Safety Evaluation Report

Related to the License Renewal of
the Millstone Power Station,
Units 2 and 3

Docket Nos. 50-336 and 50-423

Dominion Nuclear Connecticut, Inc.

Figure A: Trend Line Relationship with Horizontal Tendons

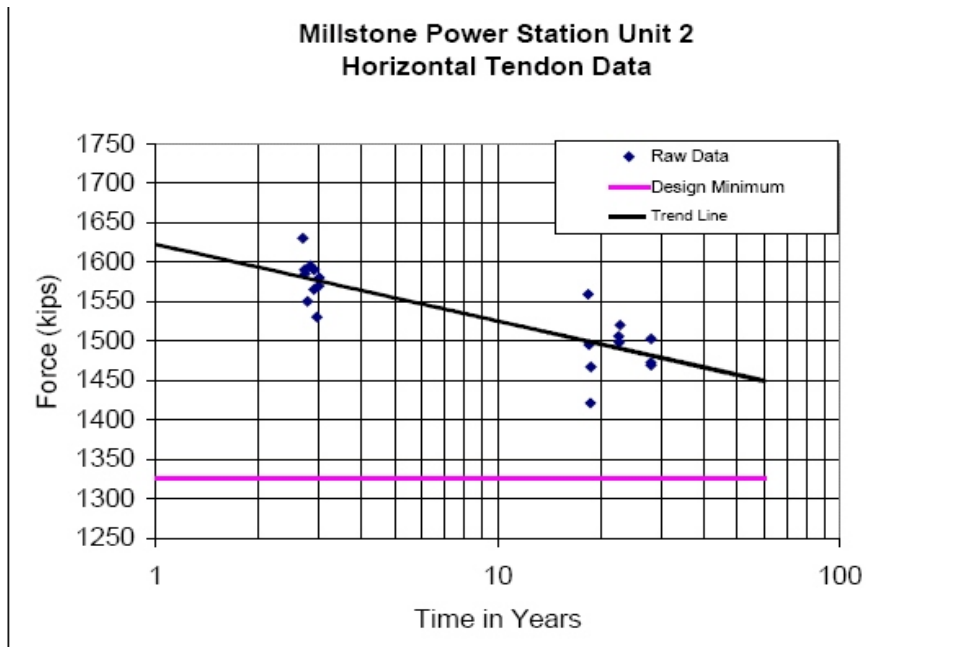
each group of tendons. In response to the staff's follow-up question as to why 3-, 5-, and 10-year data are missing from the tables, the applicant stated that as these tendons went through repeated tensioning and detensioning, the data were not reliable. The measurements taken during the 1-, 15-, 20-, and 25-year inspections were used for developing the trend lines. In Figures 1, 2, and 3 of the revised response (dated January, 11 2005), the applicant provided the trend lines and the measured tendon force data. Figure A, showing the trend line related to horizontal tendons, is reproduced below:

In its January 11, 2005 response, the applicant removed the tables provided in the LRA, and substituted new tables showing measured prestressing forces during tendon inspections for
